CROSSROADS MIXED USE FILING NO. 1

SIGNAGE AND STRIPING PLAN

S112 SHEET 12 OF 24

Figure 13: Roundabout, Plan View

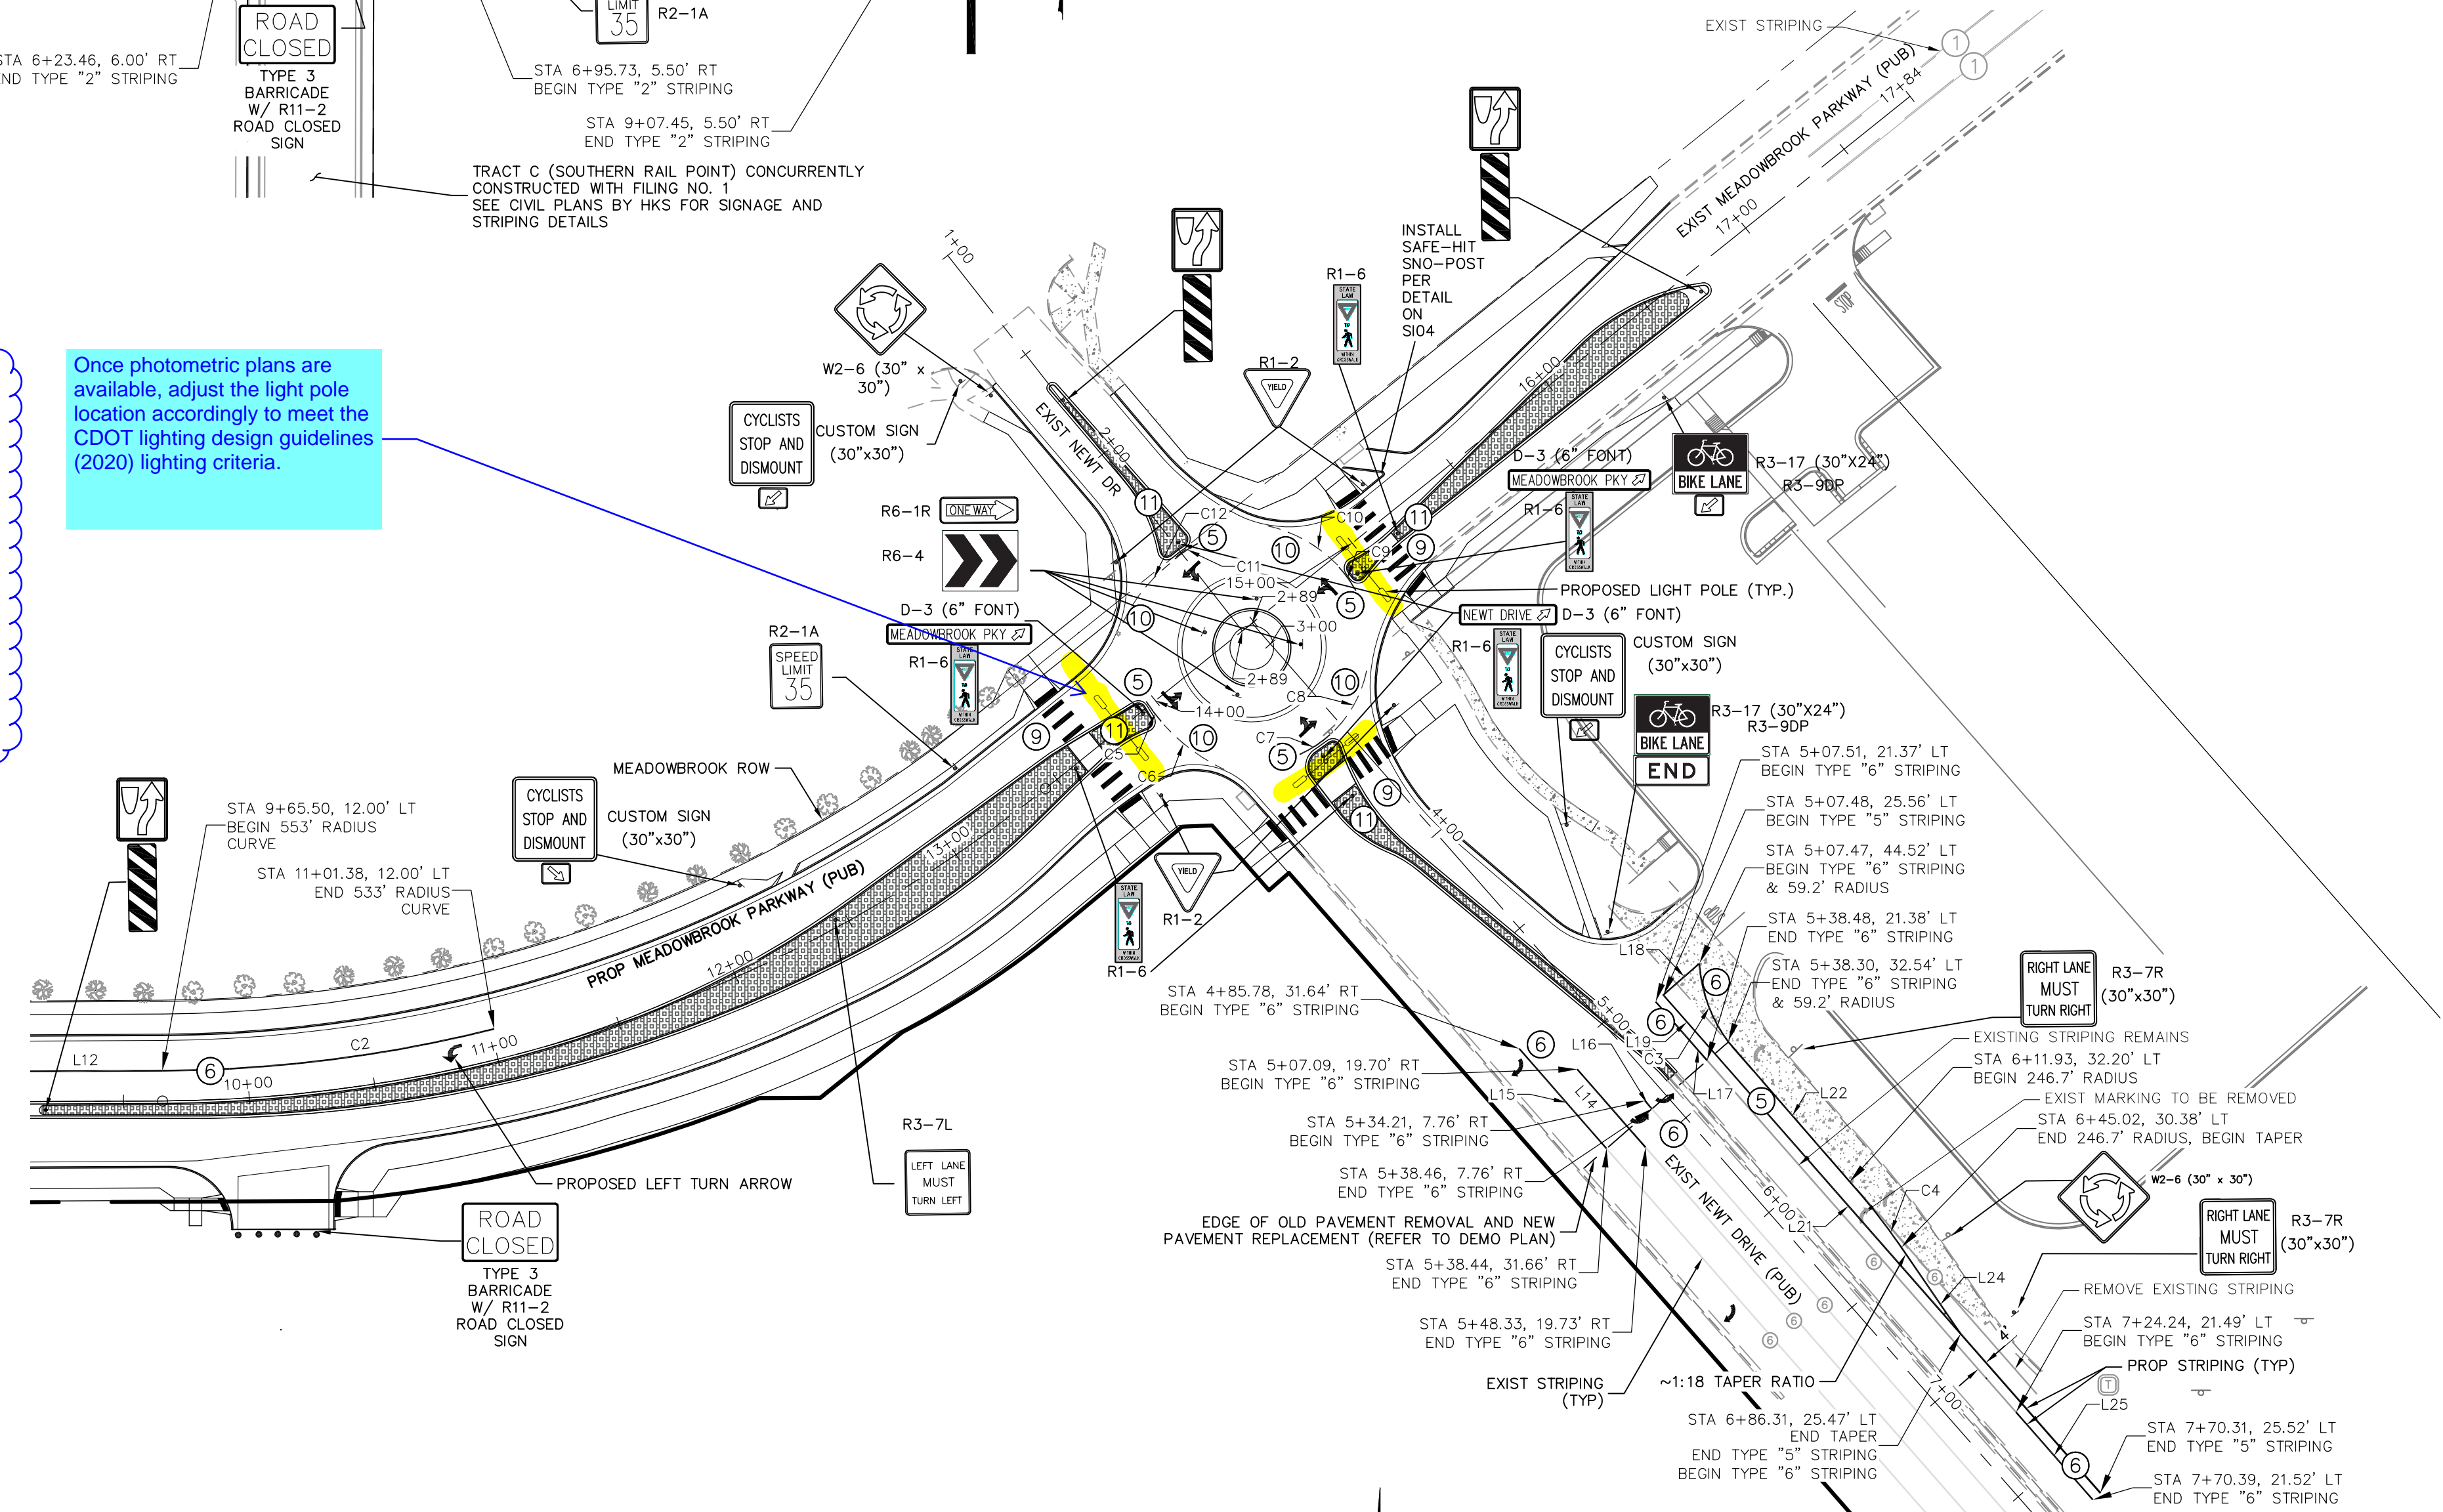
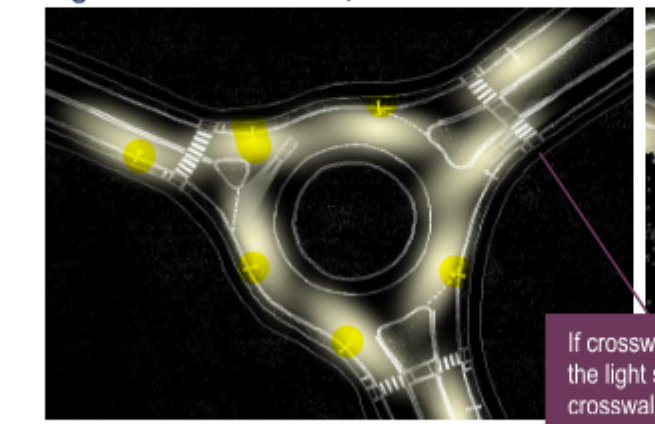
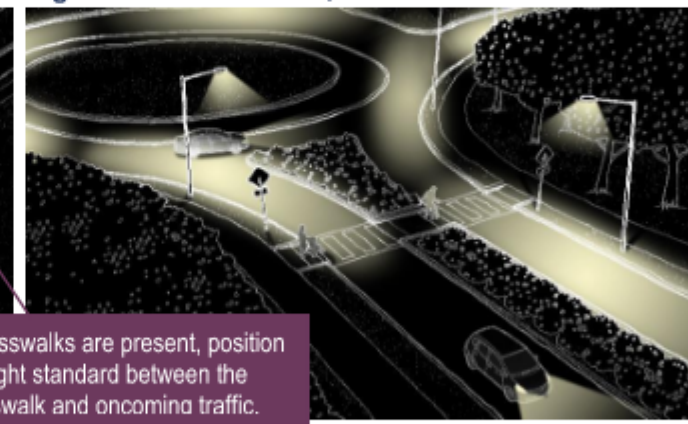
If crosswalks are present, position the light standard between the crosswalk and oncoming traffic.

Once photometric plans are available, adjust the light pole location accordingly to meet the CDOT lighting design guidelines (2020) lighting criteria.
